ADMINISTRATIVE APPROVAL (ASV) ADD2025-00049

ADMINISTRATIVE APPROVAL
LEE COUNTY, FLORIDA

Consolidated Review Comments

Project Name: BOKEELIA POINTE AD VAR REQUESTS

SKETCH TO ACCOMPANY DESCRIPTION: (PROPOSED)

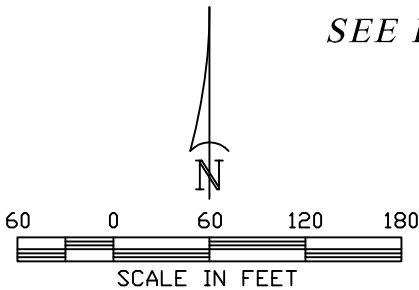
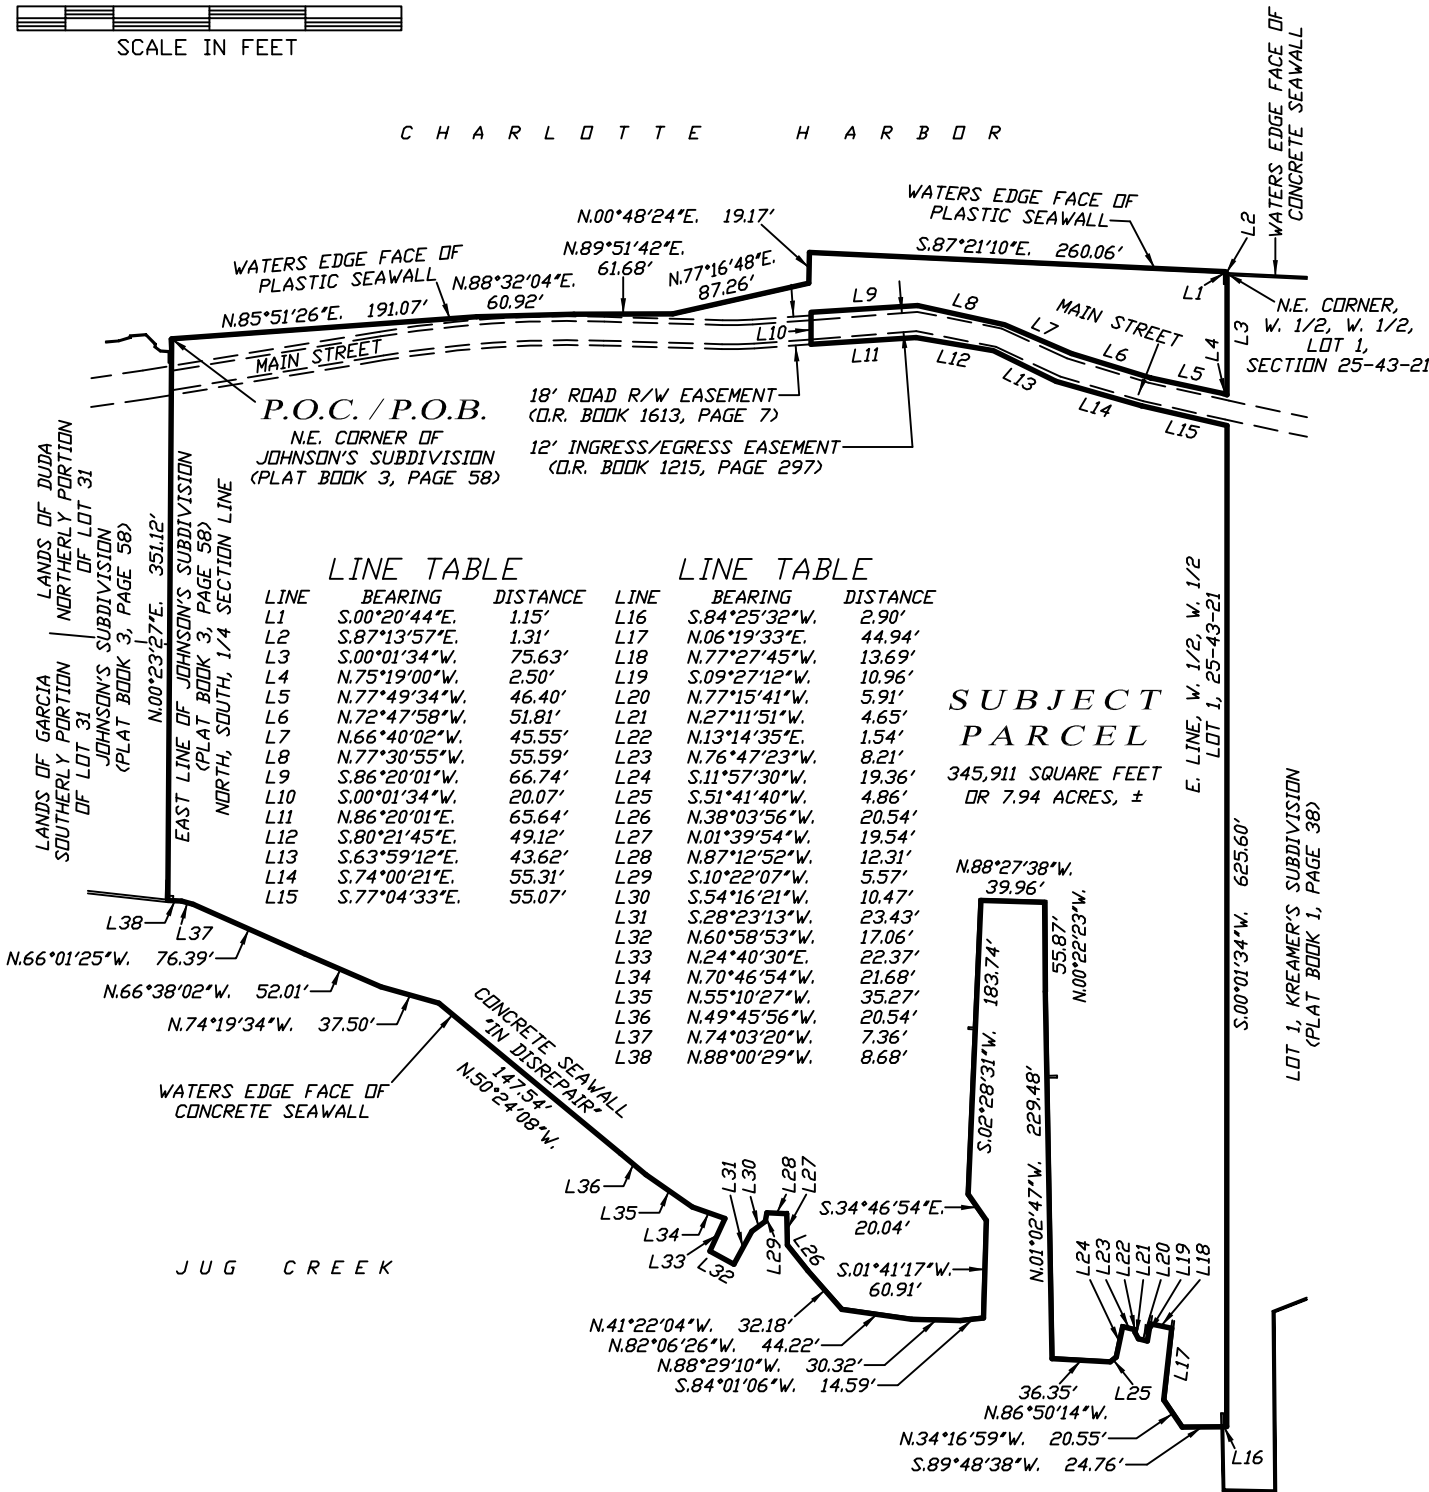
<u>Corrections</u>	<u>Review Comments</u>	<u>Reviewer</u>	<u>Status</u>	<u>Comment ID</u>
<u>Legal Review</u>				
Yes	Legal Sec. 34-203(a). - Submittal requirements for administrative action applications. (5)STRAP (Section, Township, Range, Area, Parcel) number for the subject property. The line description for the line beginning at the NE corner of the W½ of the W½ of Lot 1 is missing the direction call. The direction call is listed on the sketch. Please update the description to include the directional call.	Richard Burris	Open	1

<u>Corrections</u>	<u>Page Ref</u>	<u>Review Comments</u>	<u>Reviewer</u>	<u>Status</u>	<u>Comment ID</u>
<u>Legal Review</u>					
Yes	2	Previous comment was not addressed	Richard Burris	Open	4
Yes	2	Clip from Sketch	Richard Burris	Open	5
